Editorial changes in Cor1/D4 to resolve inconsistency with .16e

Masoud Olfat(Sprint Nextel), Peiying Zhu(Nortel) and Charlie Zhang(Nokia)

We propose editorial text changes to make section 8.4.5.4.10 and 8.4.5.4.10.1 consistent in both Cor1/D4 and . 16e. This document describes the text changes necessary in .Cor1/D4.

Figure 230a – Post Processing CINR for MIMO Region

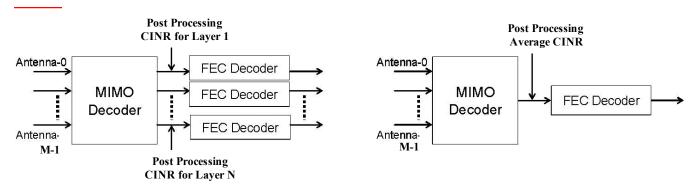
[Replace Figure 230a by the following figure]:
